# DART SERVICE INSTRUCTION

TO AMEND INSTALLATION INSTRUCTIONS IIN-D412-702 REV. D & E

A	NEW ISSUE	LE	08.03.05
REV.	DESCRIPTION	BY	DATE
DESIGN		<b>DART AEROSPACE LTD</b>	
DRAWN		HAWKESBURY, ONTARIO, CANADA	
CHECKED		DRAWING NO.	REV. A
MFG. APPR.	N/A	DSI 9408	SHEET 1 OF 1
APPROVED		TITLE	SCALE
DE APPR.		HOOK AND LOOP STRIP	NTS
DATE	08.03.05	COPYRIGHT © 2008 BY DART AEROSPACE LTD <small>THIS DOCUMENT IS PRIVATE AND CONFIDENTIAL AND IS SUPPLIED ON THE EXPRESS CONDITION THAT IT IS NOT TO BE USED FOR ANY PURPOSE OR COPIED OR COMMUNICATED TO ANY OTHER PERSON WITHOUT WRITTEN PERMISSION FROM DART AEROSPACE LTD.</small>

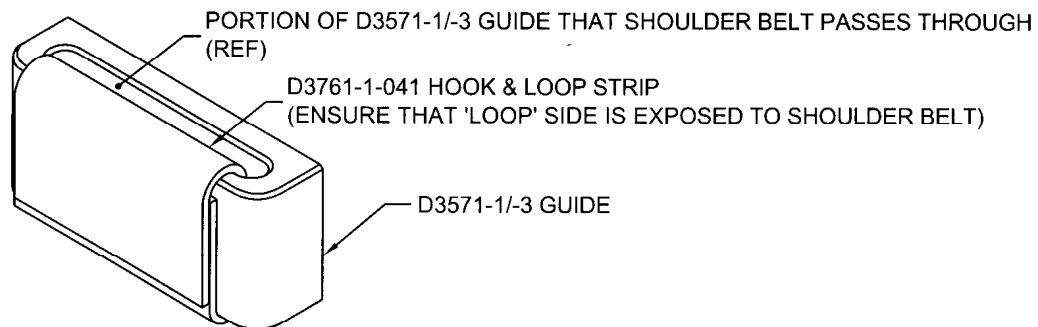
The DSI9408 kits provide D3761-1-041 hook and loop strips that help prevent passengers from inadvertently pulling the shoulder belts out of the D3571-1/-3 guides. Installation of the D3761-1-041 hook and loops strips is optional.

The D3761-1-041 hook and loop strip is installed by wrapping the strip tightly around the front face of the D3571-1/-3 guide so that the "loop" side of the strip is exposed to the shoulder belt as shown in the figure below. The kits are as follows:
